**MINUTES
TOWN OF AMHERST
DESIGN ADVISORY BOARD MEETING
August 25, 2022
6:00 PM**

- 1.1. DESIGN ADVISORY BOARD REVIEW, SP-2022-05; PROPOSED 40-UNIT APARTMENT BUILDING
Property Located at 7740 Transit Road
7740 Transit Road, Inc., Petitioner

TOWN OF AMHERST
DESIGN ADVISORY BOARD
DESIGN REVIEW FINDINGS
SP 2022-05

SITE PLAN

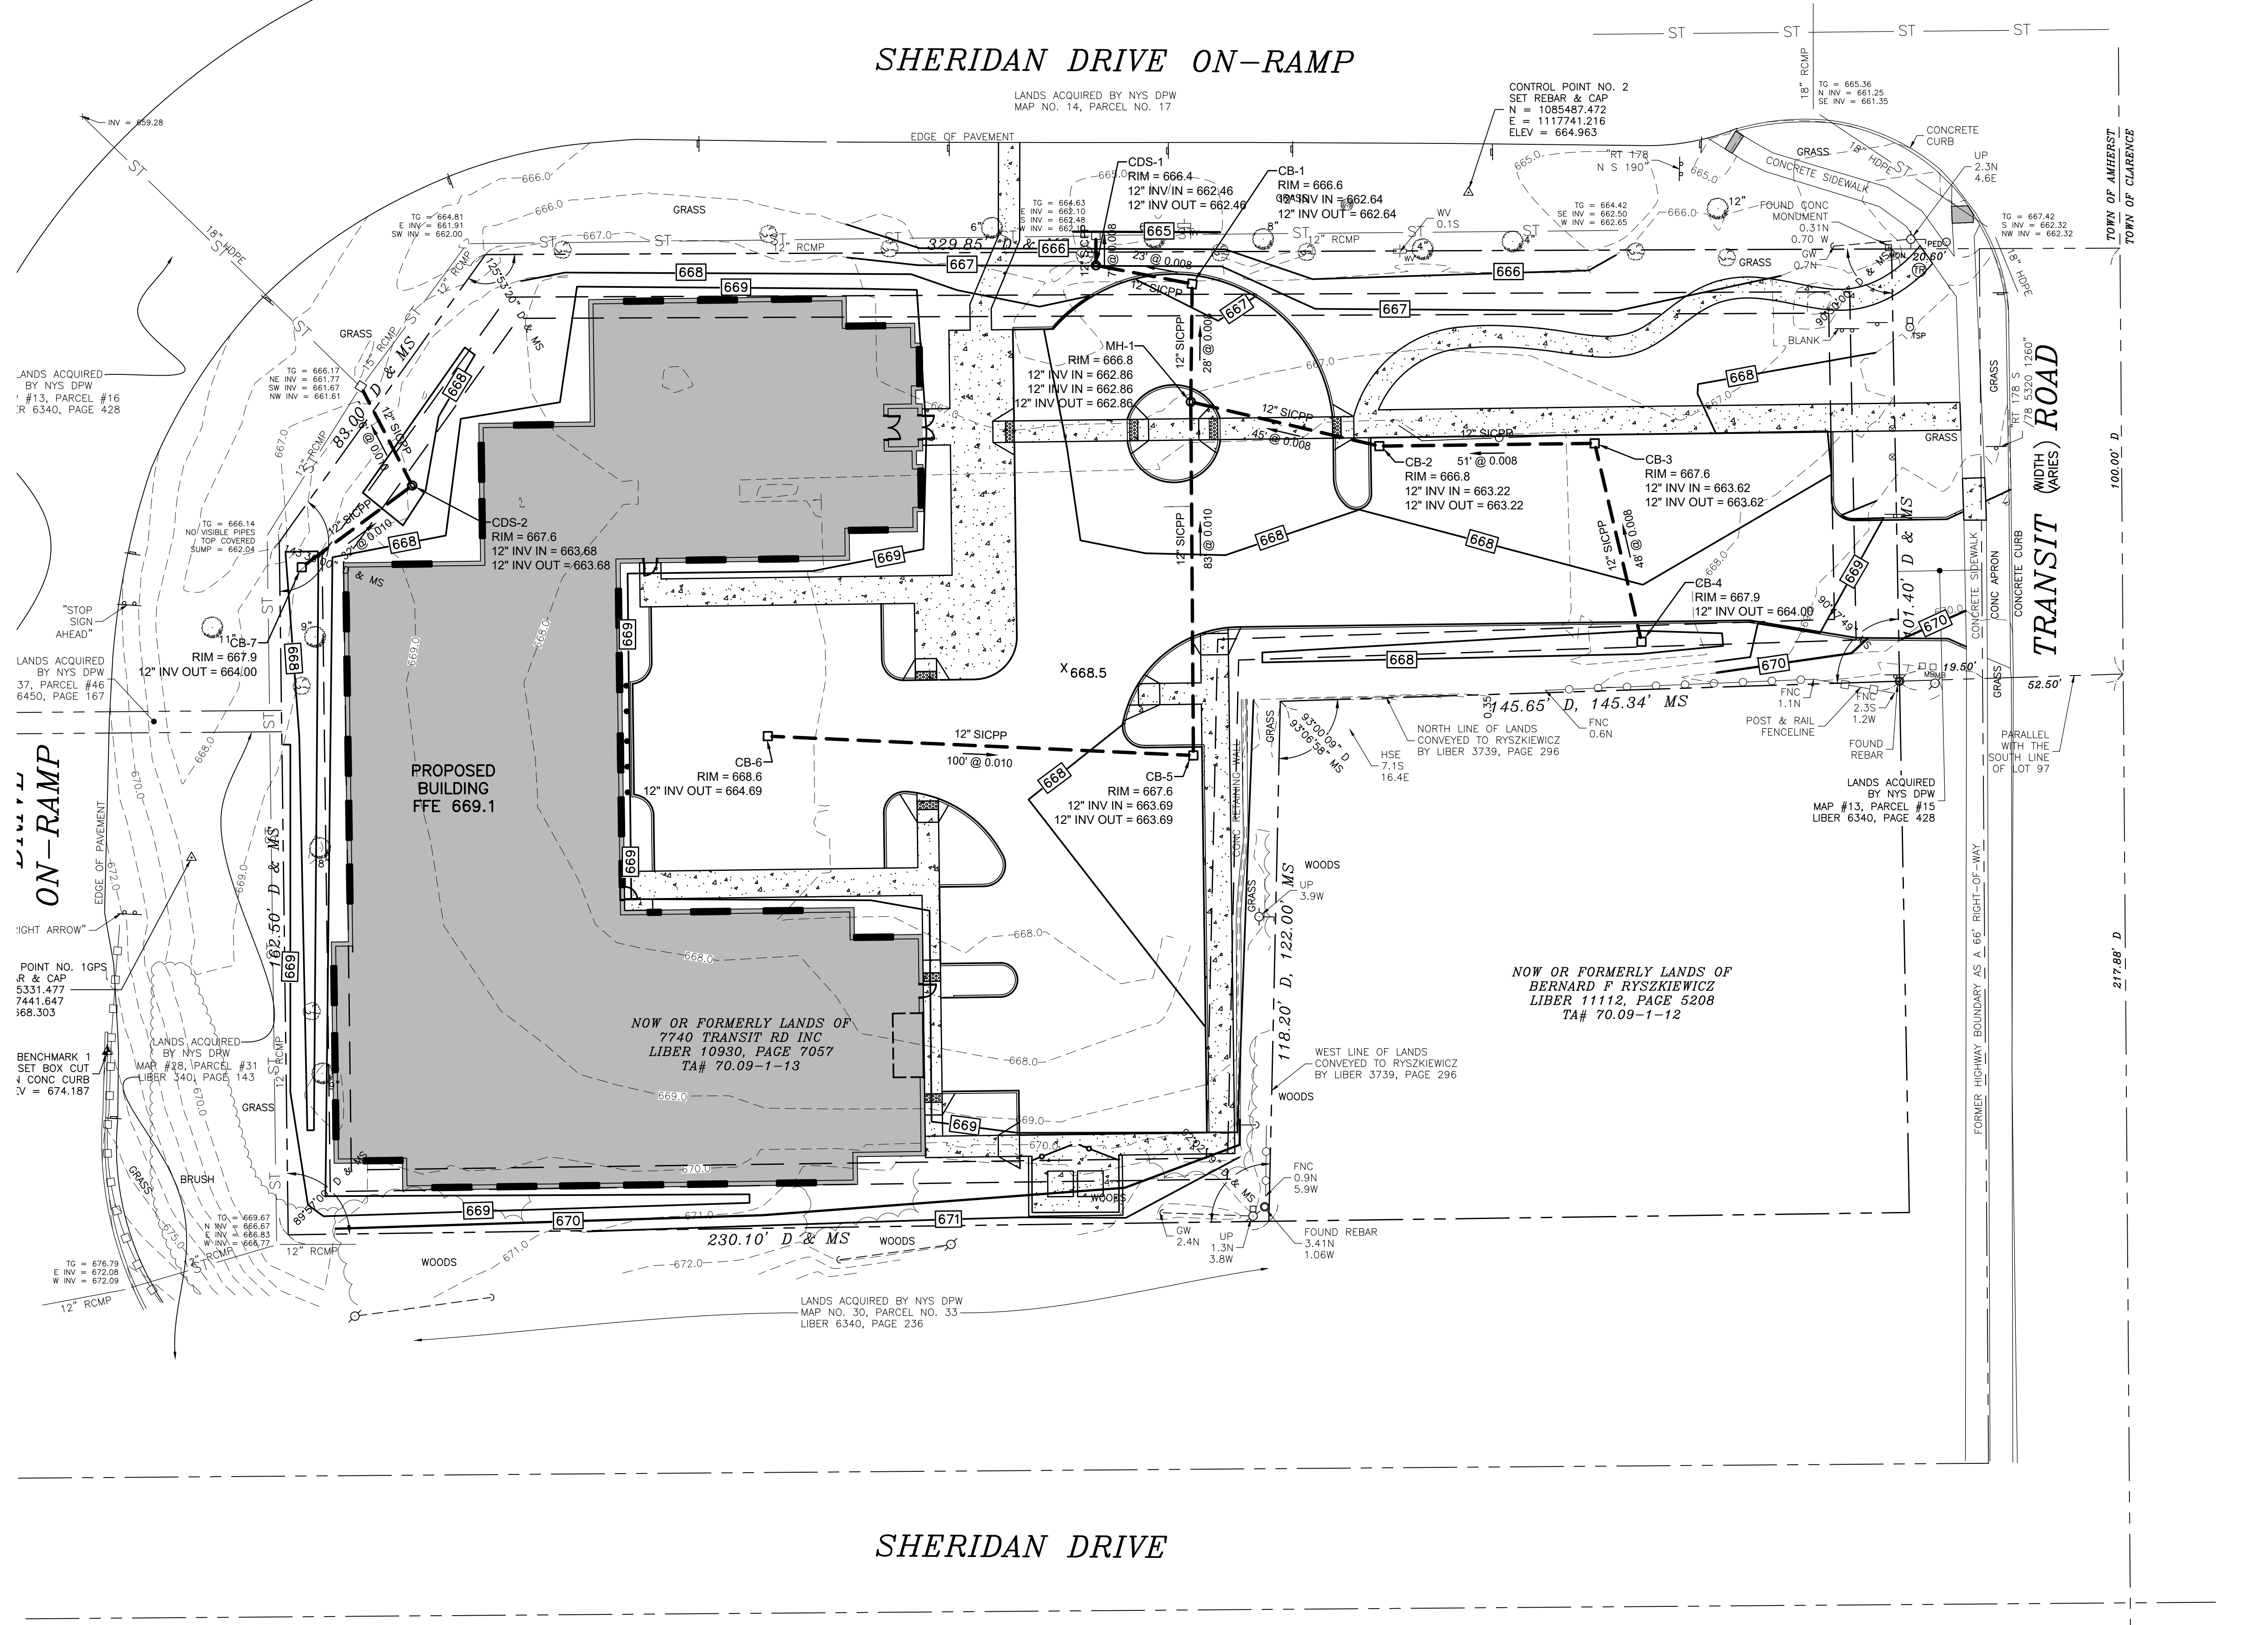
Mr. Talty and the Board acknowledged additional sidewalks for connectivity was impractical due to the site's size and location. Ms. Conhiser-Uy noted the northern sidewalk leading towards the Sheridan Drive ramp seemed to have no purpose. The Board agreed that section should be removed or connected to another section of sidewalk.

Ms. Colucci recommended they add park benches, tables, and lighting to the eastern "park area" to make it more useable.

Mr. Giuliani suggested they reach out to local artists to incorporate public art into the site and to which Ms. Sabharwal agreed. Mr. Talty pointed out that the traffic circle to the building's east side would be an ideal spot for art.

Yakun Hu, 100 Westchester Road, suggested the northern sidewalk that leads to the Sheridan Drive ramp extend to an overpass to safely encourage walkability.

- 1) That the walkway from the principal building entrance area north to the Sheridan Drive ramp be eliminated and that the internal walkway be rerouted around the vehicle use area and not through it.

- 2) That benches, tables and lighting be provided in the "park area" identified on the site plan.
- 3) That "public art" be seriously considered in the island within the vehicle use area in front of the principal building entrance.

EXTERIOR ELEVATIONS

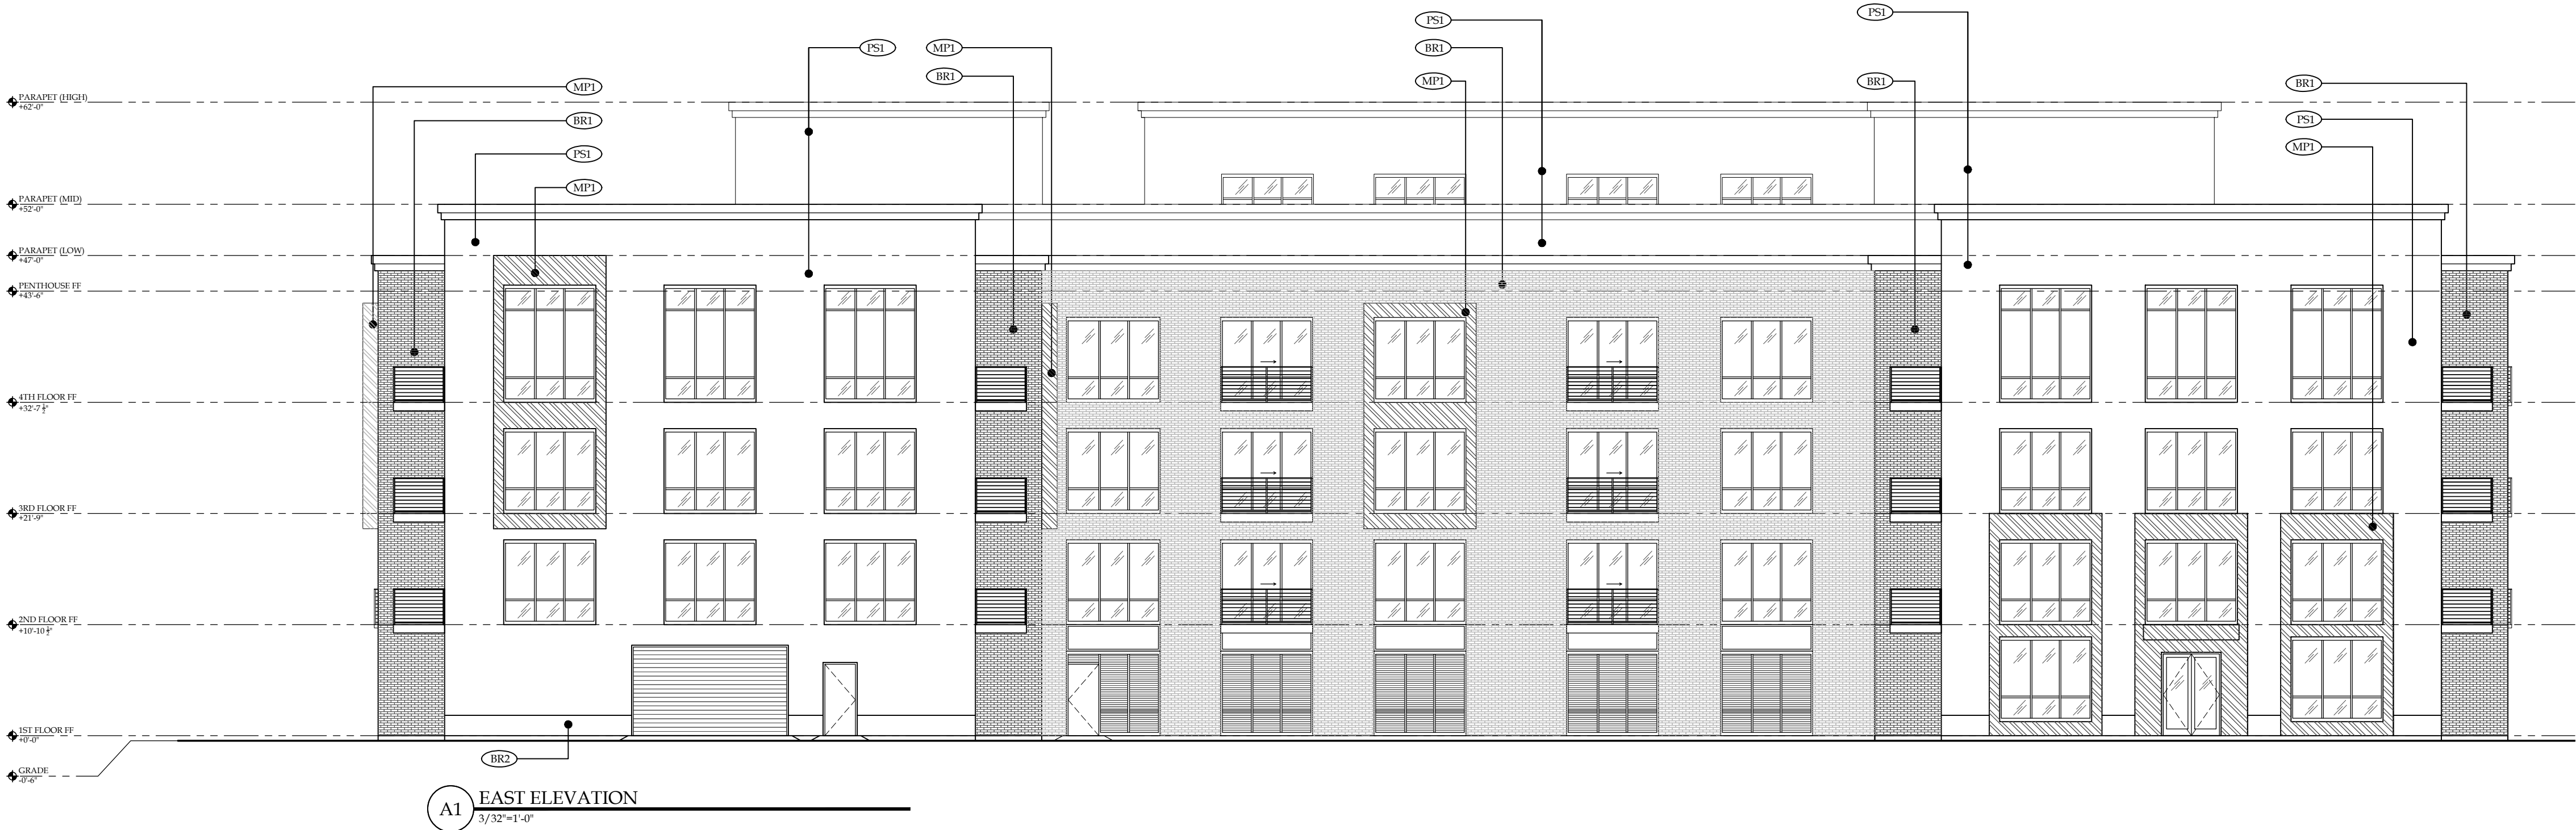
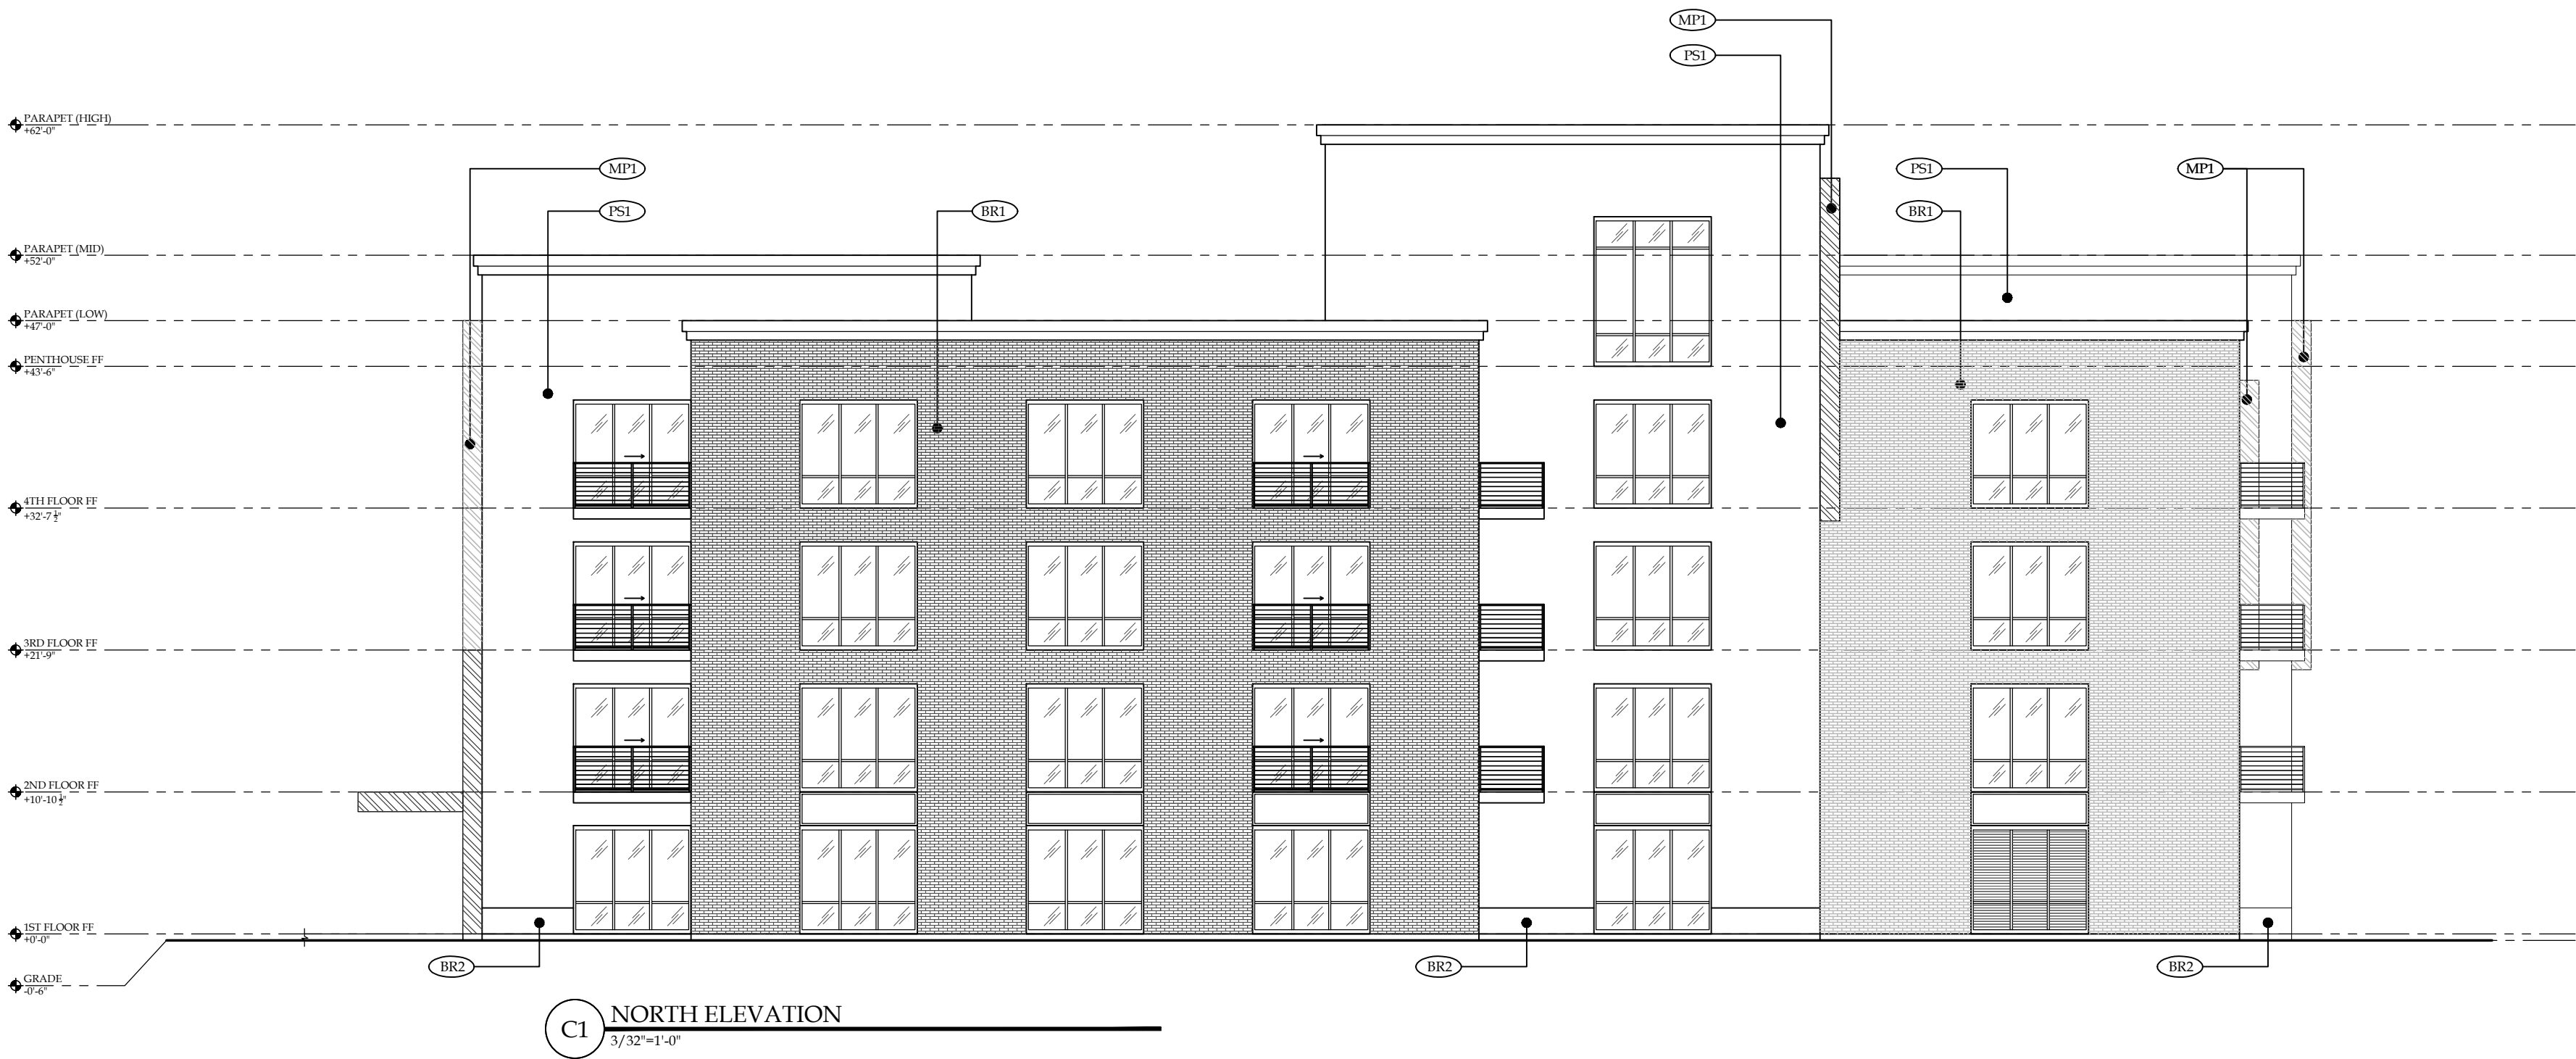
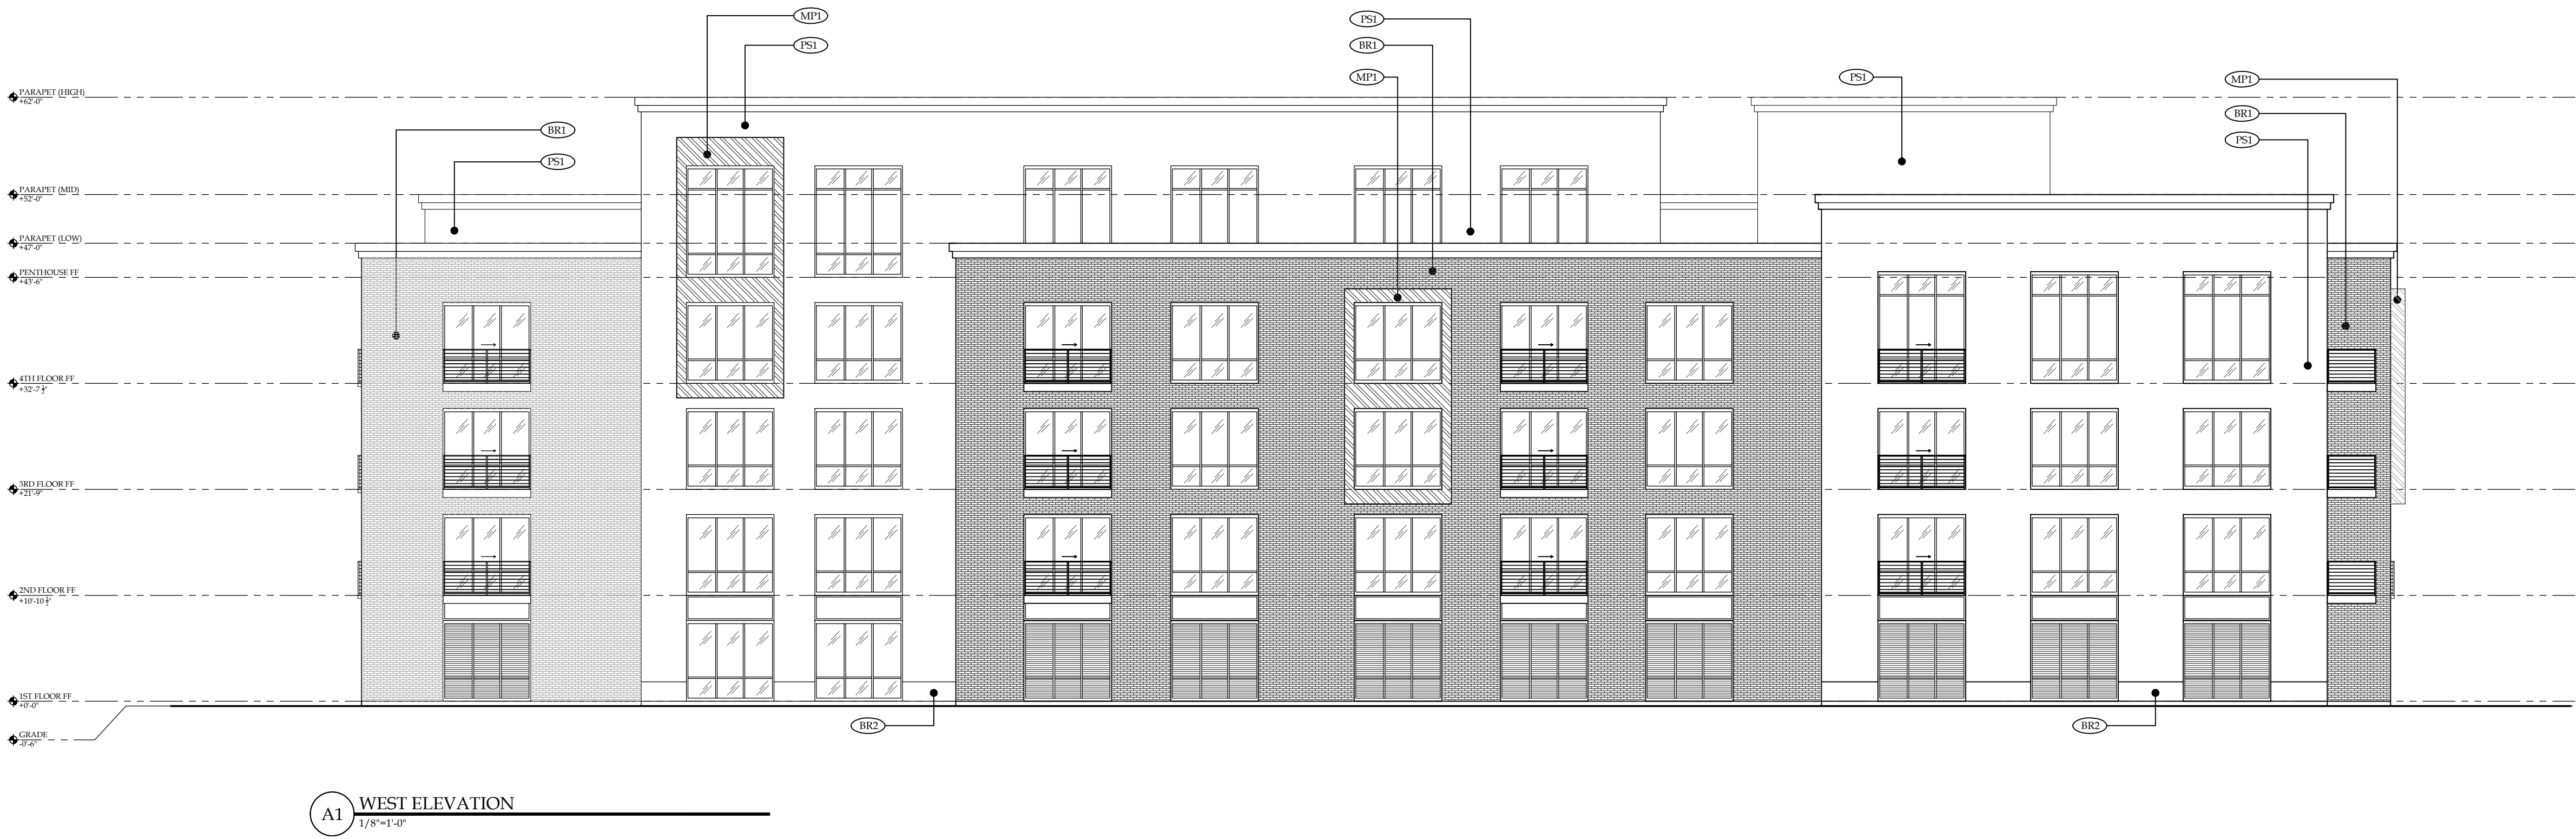
Ms. Colucci recommended they add architecturally decorative louvers to the parking garage area, which would also be consistent with the guidelines for public art inclusion in section A-4 of the Design Guidelines.

Mr. Giuliani requested the lifespans of the exterior materials be provided. Ms. Hunt agreed to find and share this information. Ms. Hunt continued that she believed the cement-board panels may have a lifespan of twenty - thirty years while bricks generally have greater longevity. Additionally, she understands low-grade cement panels are lower quality but they selected higher-grade cement panels.

- 5) That any existing trees within the New York State Department of Transportation rights-of-way be retained and protected during construction.
- 6) That decorative architectural louvers be used on the vent areas for the parking garage.

8) That the anticipated lifespan of the proposed building materials be provided.
